### STAFF RECOMMENDATION 1405 Elmwood Avenue April 20, 2016

**Application:** New construction-outbuilding; Setback determination  
**District:** Belmont-Hillsboro Neighborhood Conservation Zoning Overlay  
**Council District:** 18  
**Map and Parcel Number:** 10513043600  
**Applicant:** Tyler Lemarinel, Allard Ward Architects  
**Project Lead:** Paul Hoffman, paul.hoffman@nashville.gov

**Description of Project:** Construction of a new outbuilding at the rear of the vacant lot. A setback determination is requested from twenty feet (20') to ten feet (10'). The outbuilding is not a detached accessory dwelling unit (DADU).

**A0.1**

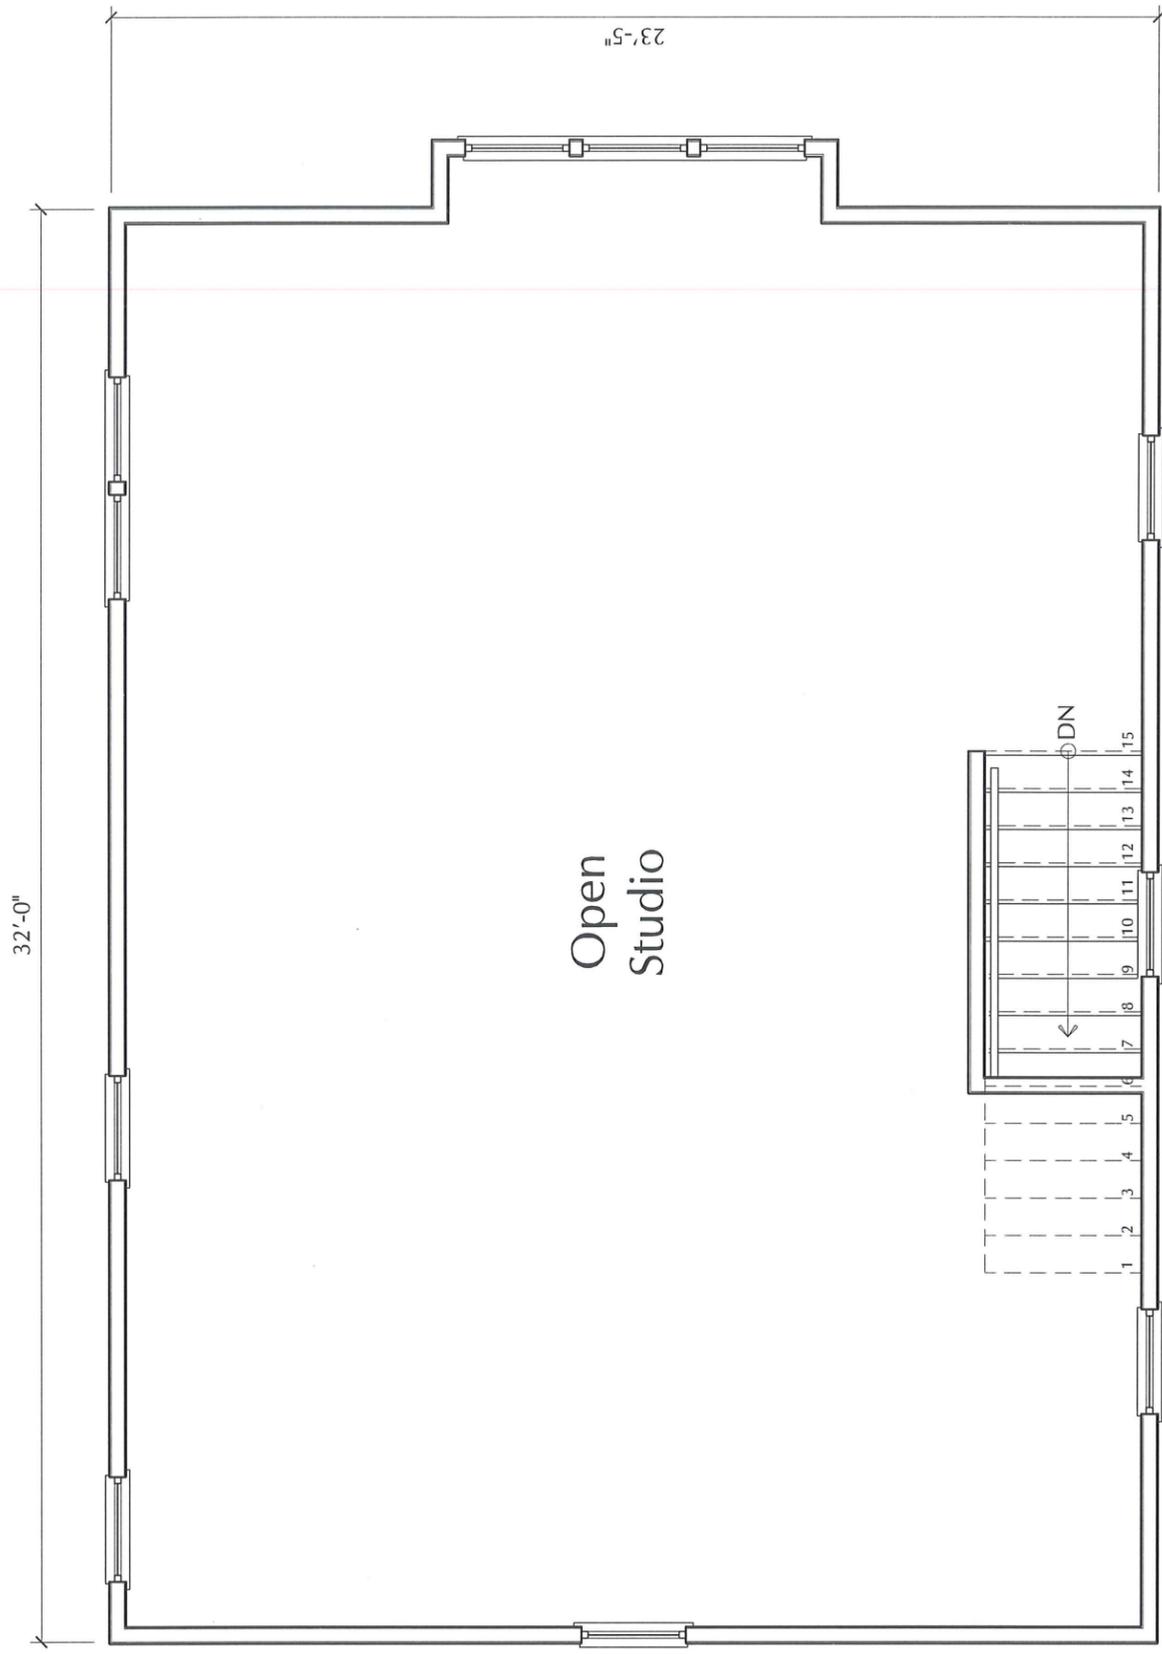
Setback & Rhythm of Spacing: The applicant requests a rear setback of ten feet (10'). An outbuilding with a footprint over seven hundred square feet (700 sq. ft.) is required by Code to be twenty feet (20') from the rear property line. Historically, outbuildings were located on or close to the rear property line. There are numerous outbuildings nearby that sit nearer to the alley than ten feet (10'). Staff finds that the setback determination meets the design guidelines.

**1** East Elevation  
 Scale: 1/4" = 1'-0"

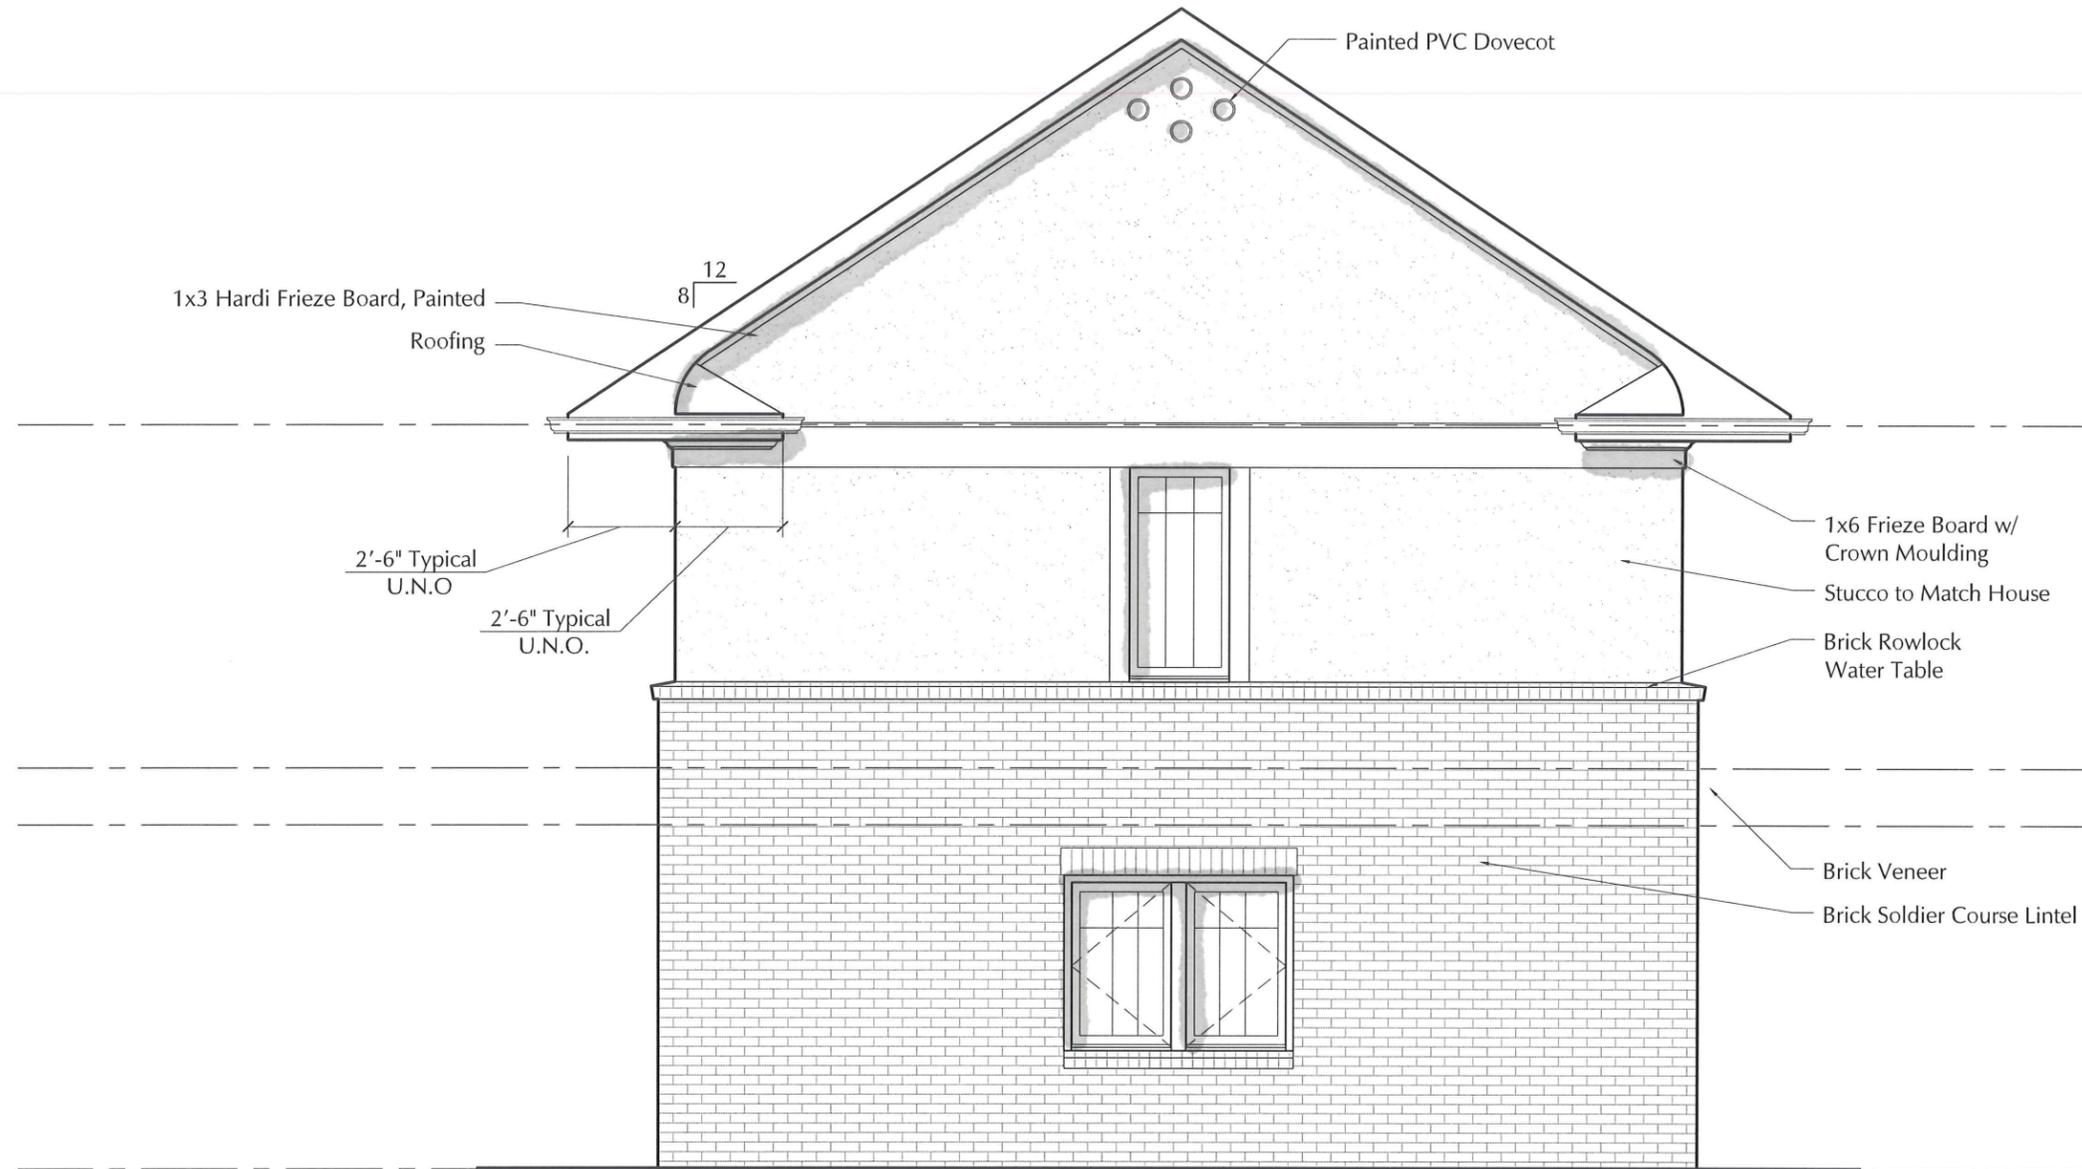
Height & Scale: The outbuilding is drawn with a ridge height of twenty-seven feet (27'). The Belmont-Hillsboro design guidelines limit the height to twenty-five feet (25'). In 2014 the Commission hosted a series of charrettes to gain input from the neighborhoods about additions, infill and outbuildings. Participants agreed that they wanted the requirements for detached accessory dwelling units (DADUs) and garages to be the same. DADUs are not allowed to exceed twenty-five feet (25') in height, according to the ordinance. (Staff has also researched DADUs in other cities and have not found any that exceed twenty-one feet (21') in height. In fact, many are significantly shorter.) In order to clarify design guideline II.B.i.1. for outbuildings, which states that outbuilding should be compatible by not contrasting greatly with surrounding historic outbuildings in terms of height, italicized information was added to explain that outbuildings should not exceed 25' in height.

Staff therefore recommends that the ridge height be reduced to twenty-five feet (25').
